LEGG ARCHITECTURE, LLC

May 03, 2023

Lion & Rose British Tavern and Pub - 23110 W I-10, San Antonio, TX 78257

ADDENDUM 1

A6.7

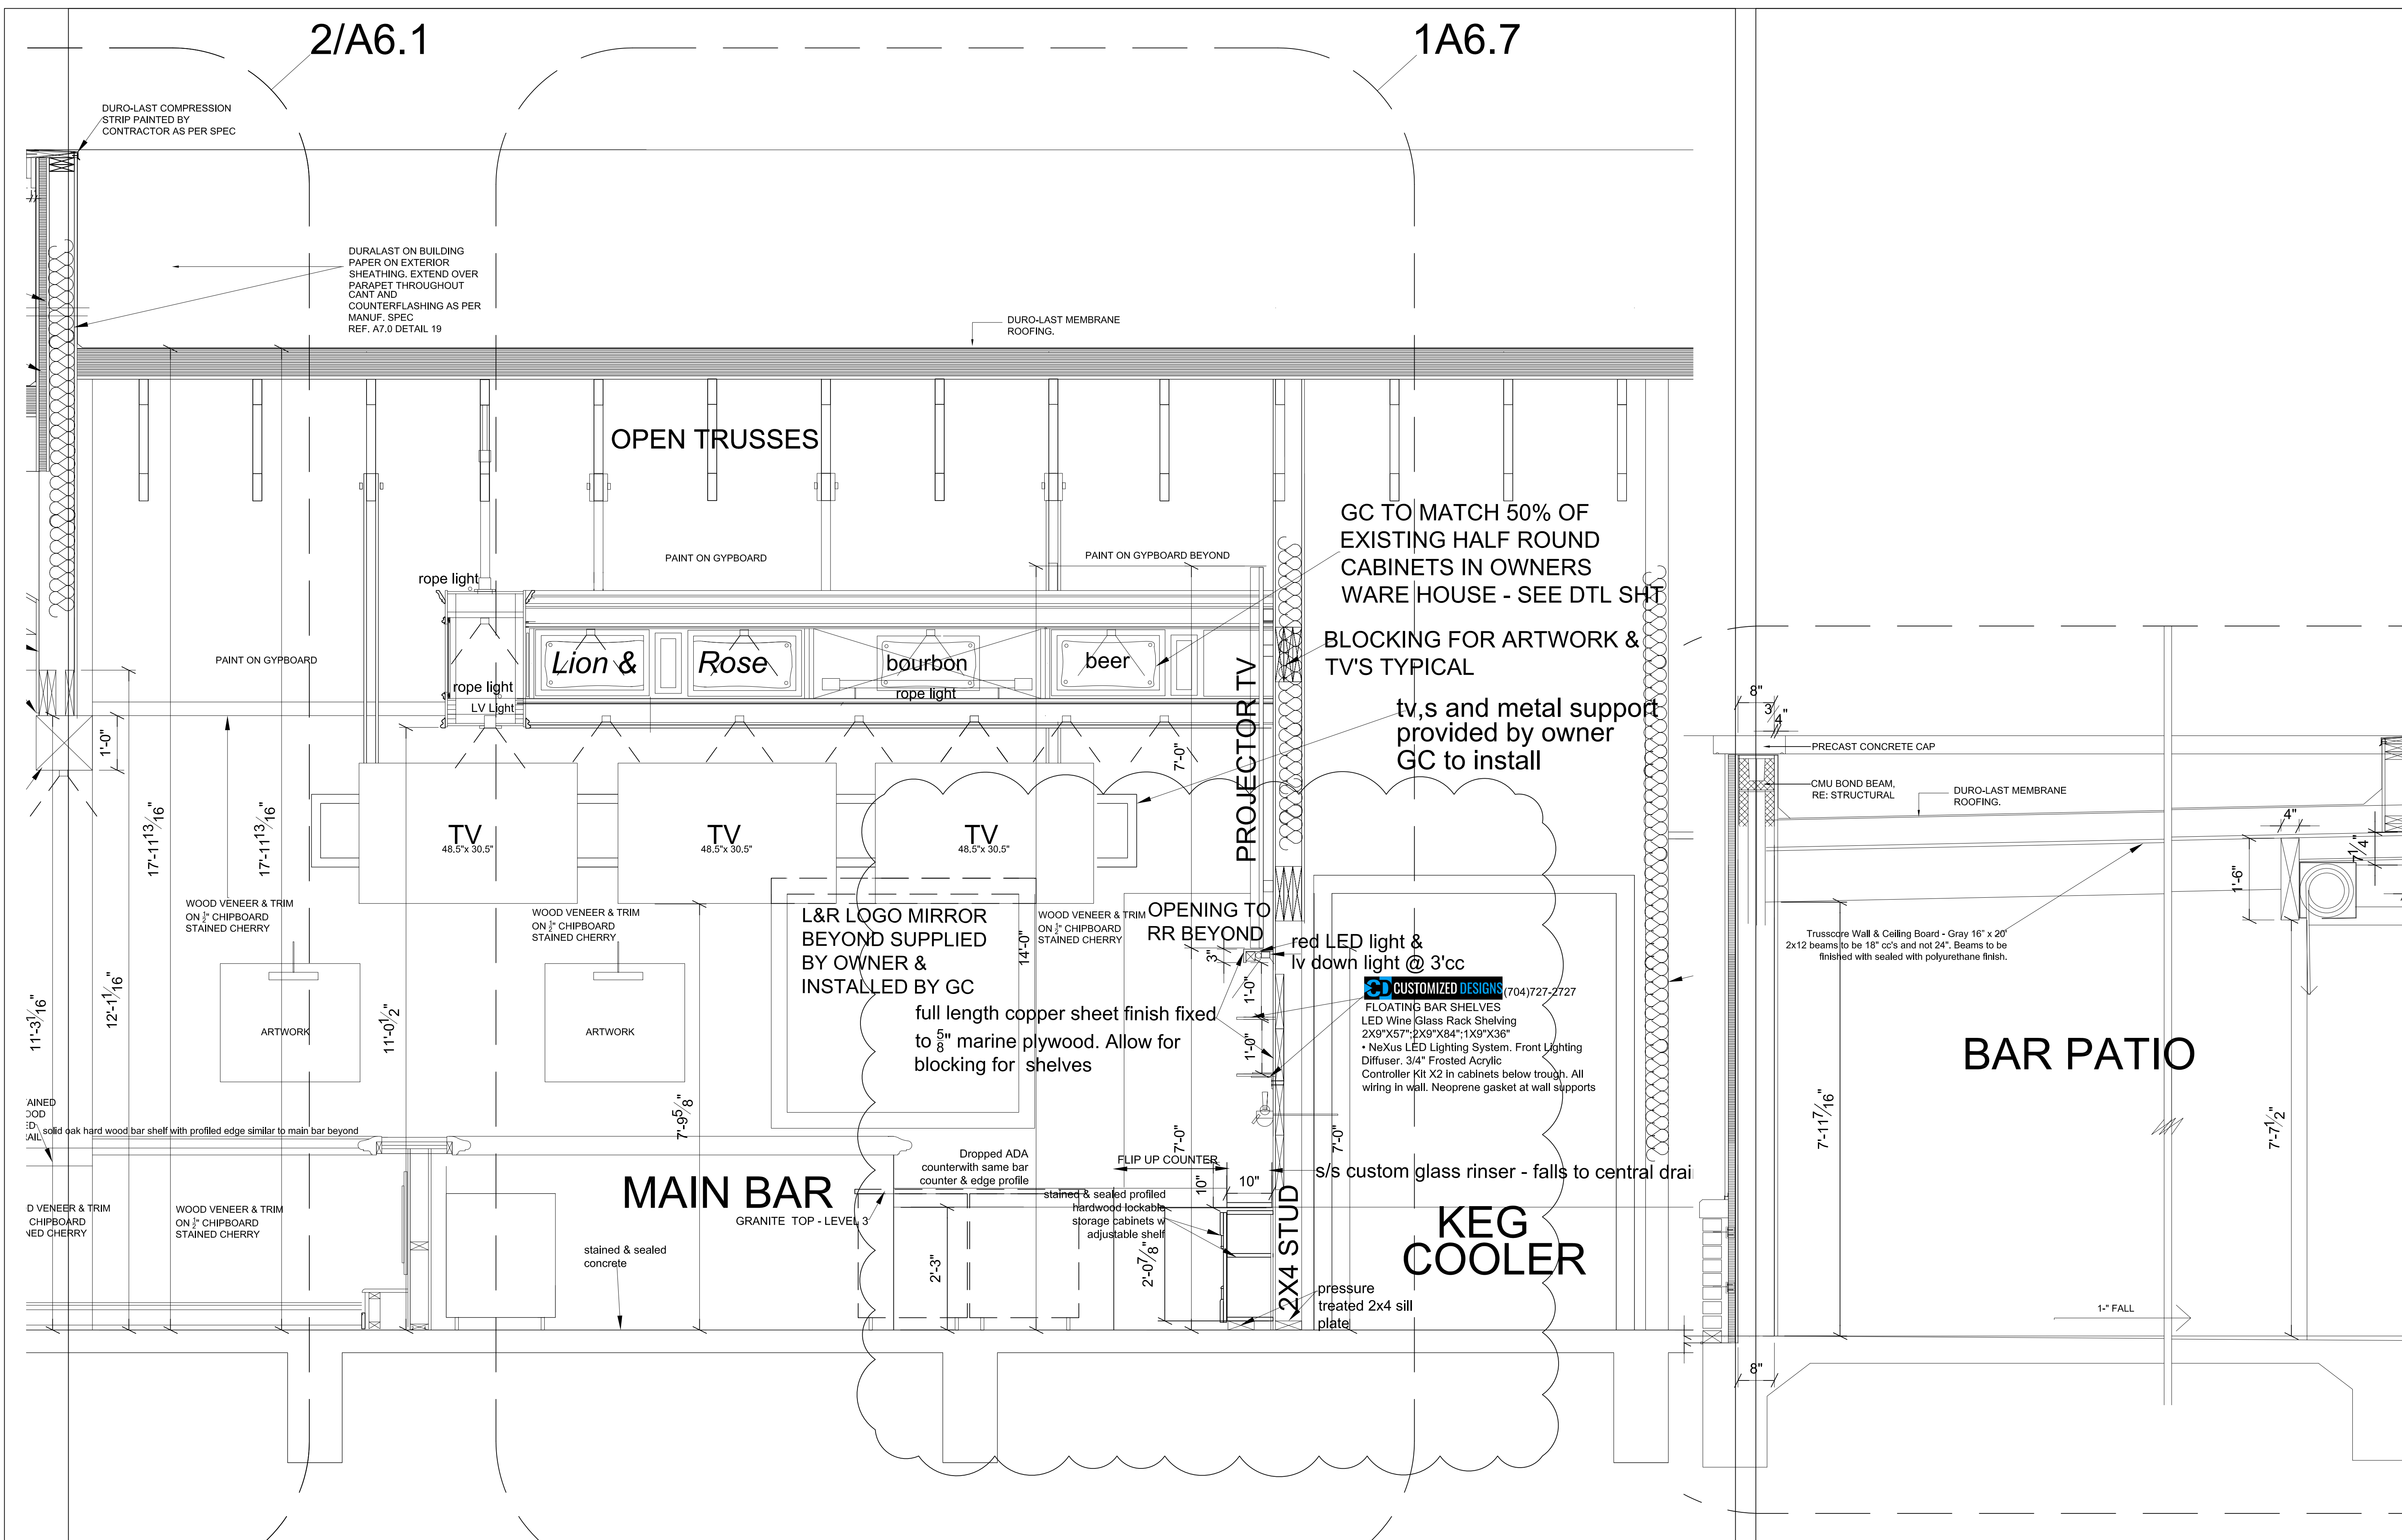
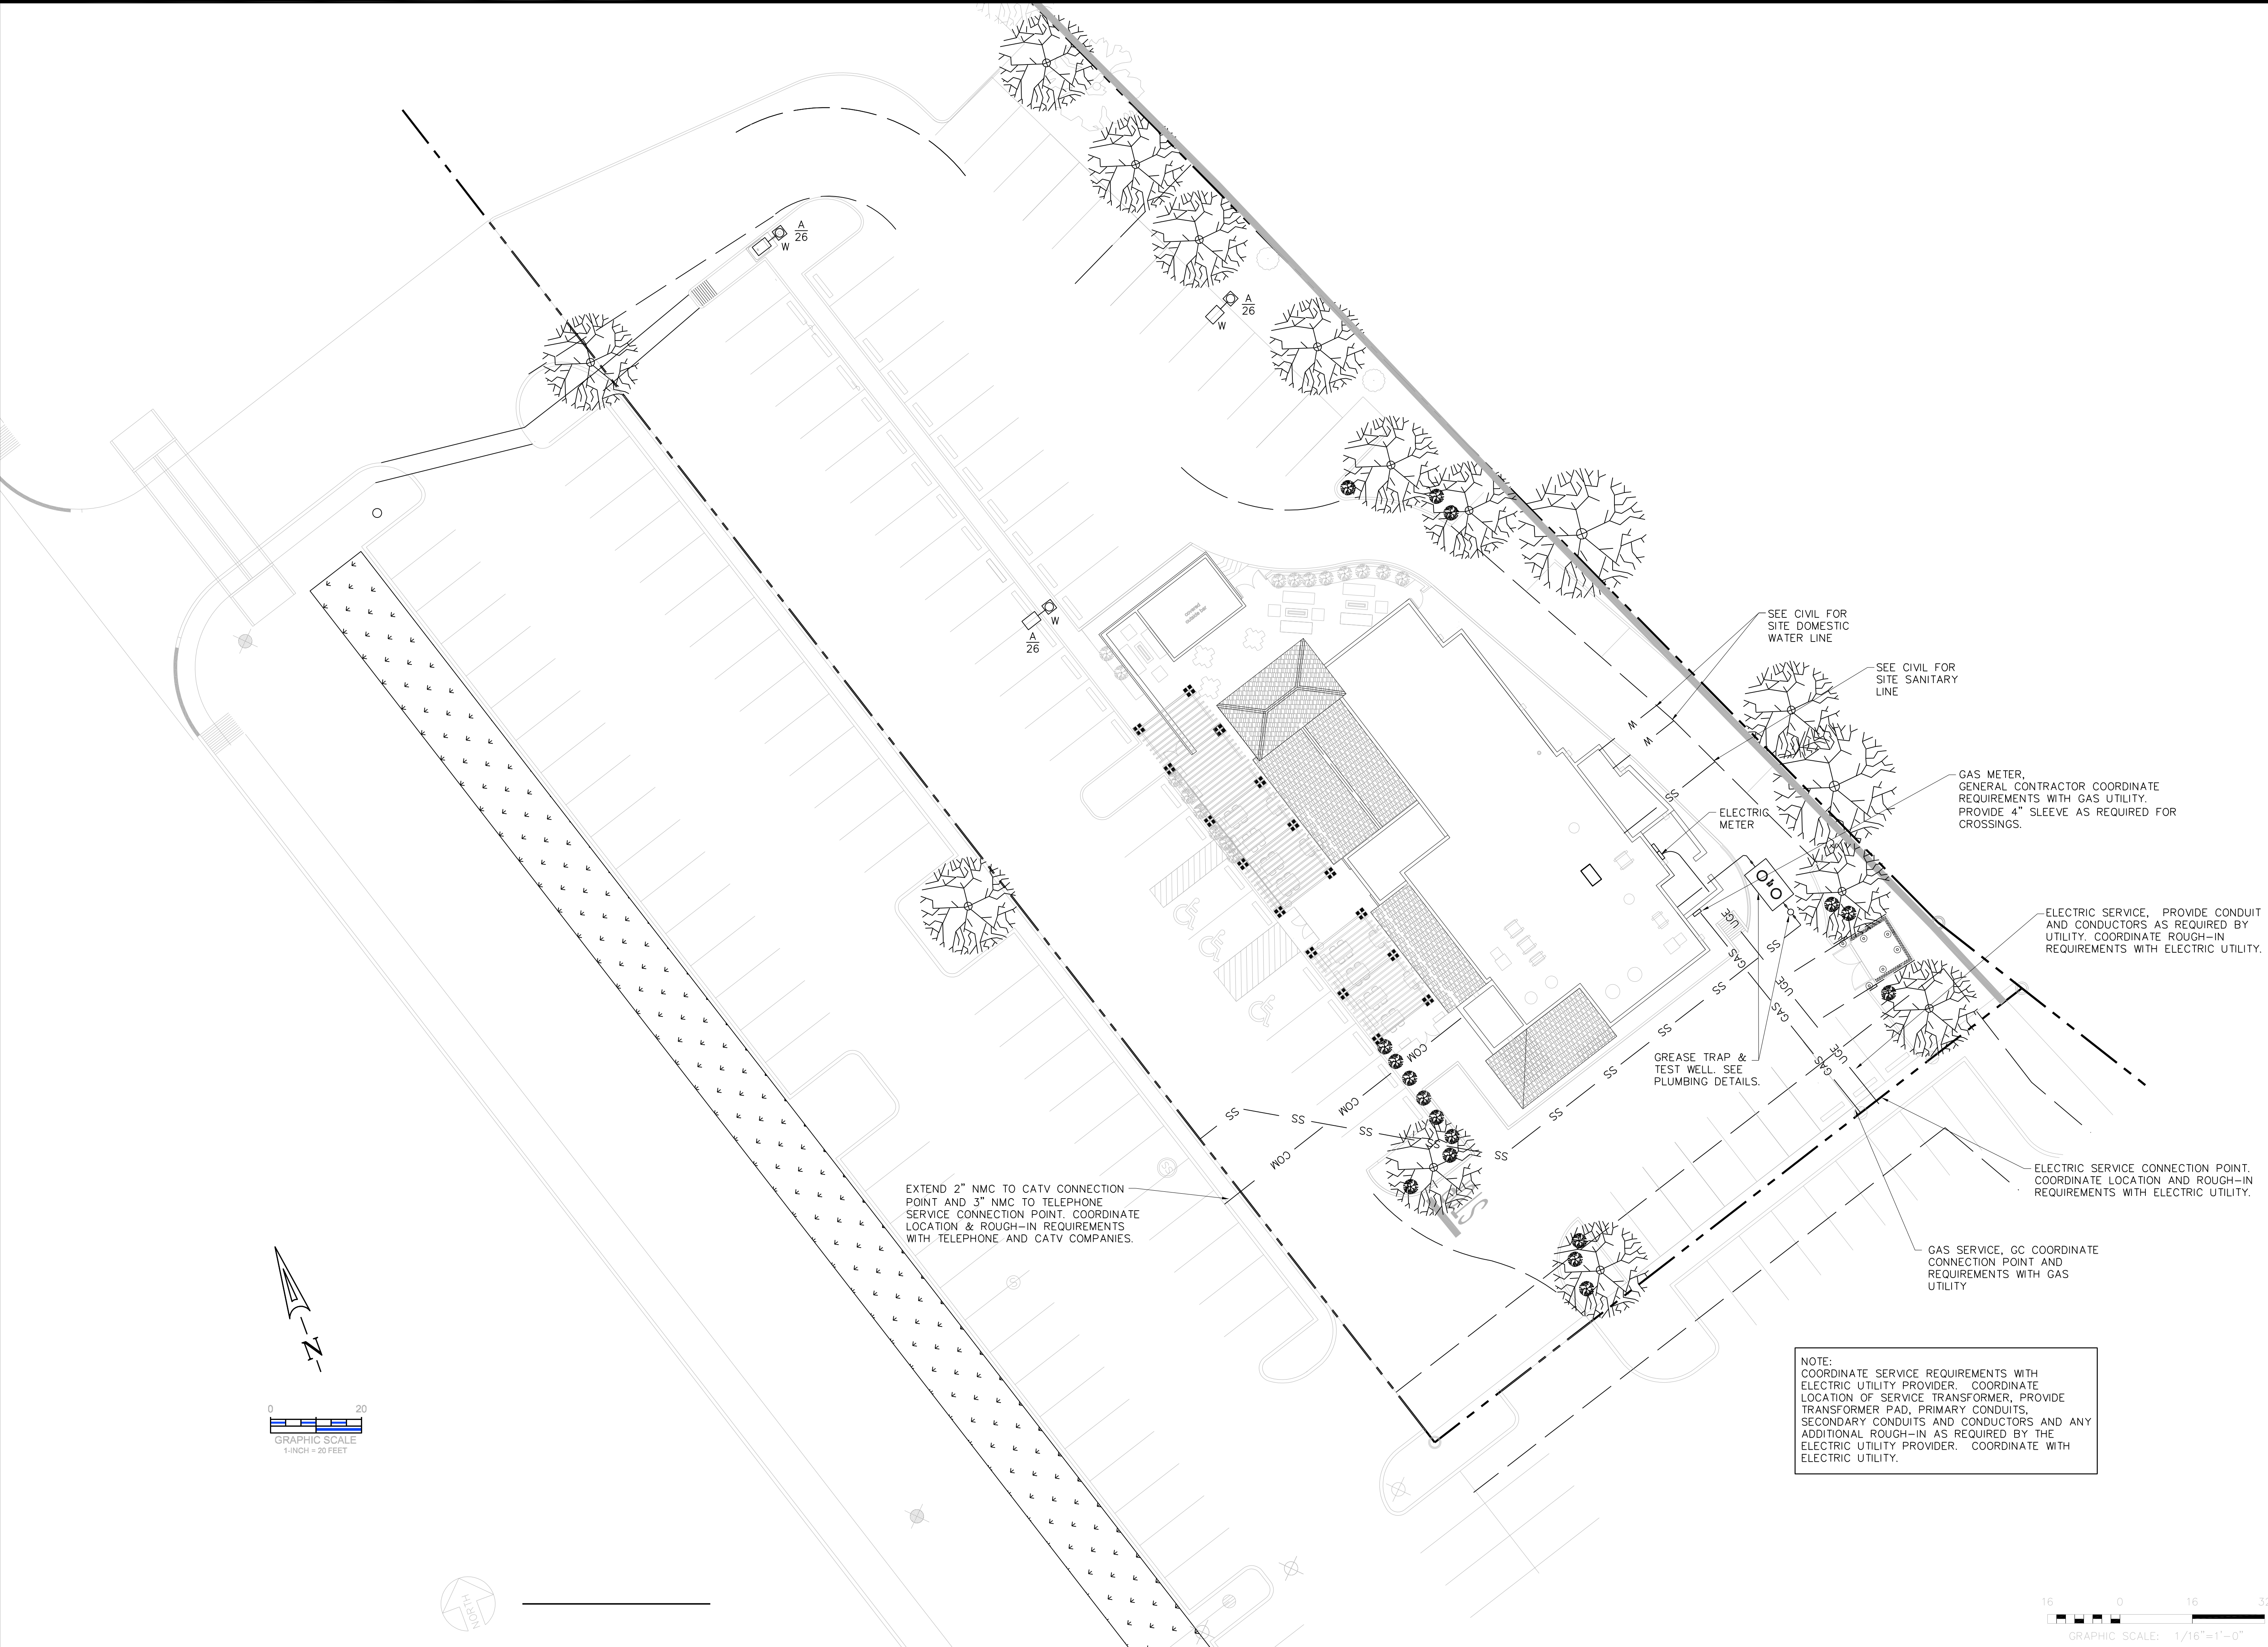
- 3.5 Sheet A2.1; A2.7; A6.6; A6.7 Granite slabs (level 3) required for main bar island and beverage counter at patio bar
- 3.6 Sheet A6.7; A2.1; A2.6 Allow for dropped ADA to main bar; patio bar and 12 seater tables
- 3.7 Sheet A2.6; A6.7 Patio Bar – COSA amendment/Ceiling finish: Trusscore Wall & Ceiling Board - White 16" x 20'2x12 beams to be 18" cc's and not 24". Beams to be finished with sealed with polyurethane finish. Walls to be finished with washable paint. Add beverage machine and bag in box with stained 7' wooden louver sliding folding doors. New hardwood display cabinet with lights added
- 3.8 Sheet A7.0 Rev 01 – 12 Seater tables to be solid smooth stained hardwood
- 3.9 GC to assist owner TV vendor with installation of TV's and mounts provided by owner.
- 3.10 Fire Sprinkler – allow for pipes to be painted
- 3.11 Stucco – expansion joints as per minimum industry standards

SHEET NO.
M2.1

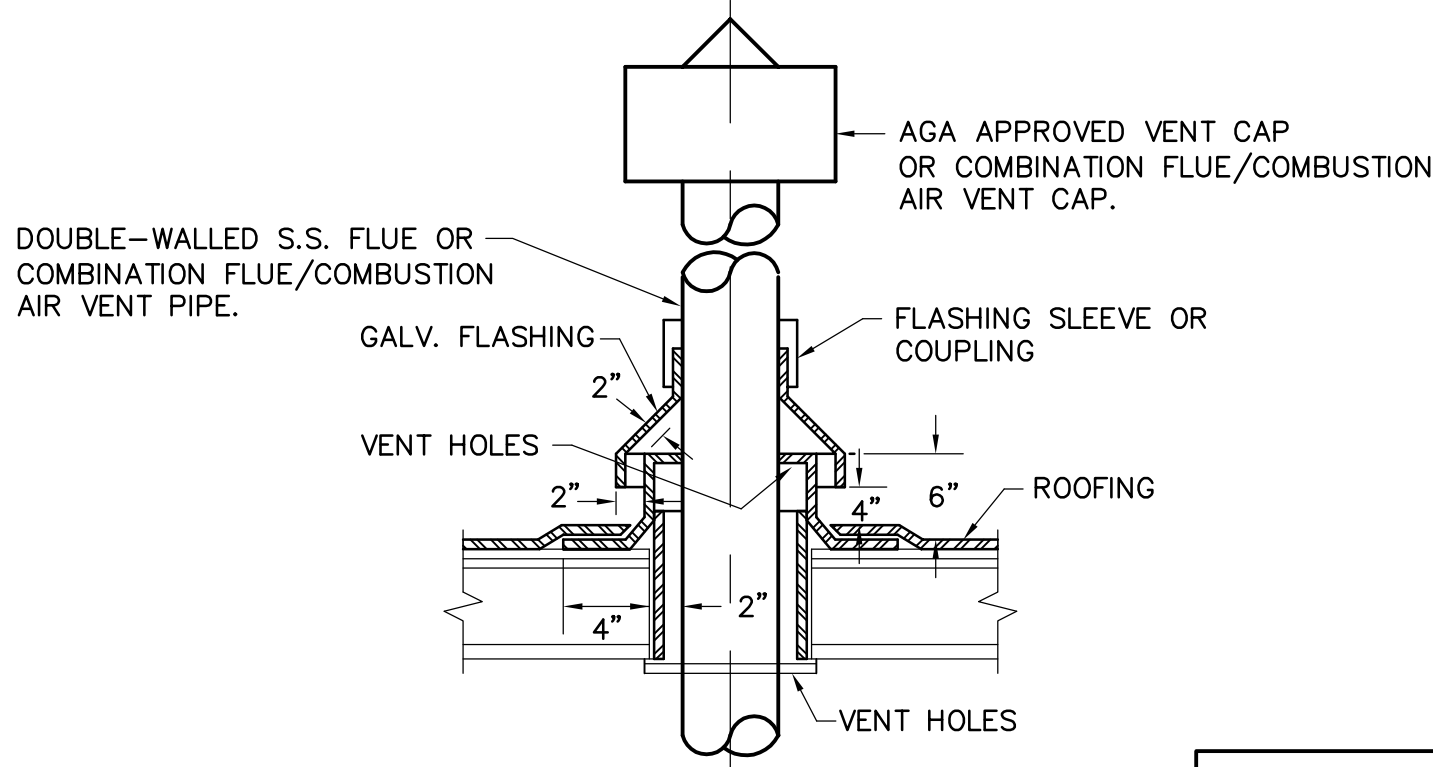
- 2.3 M2.1 Rev 02; M3.2 Rev 02; Paint specified for exposed hard ducts in main bar area
 - 2..3.1 Front patio fans to be **mister** fans
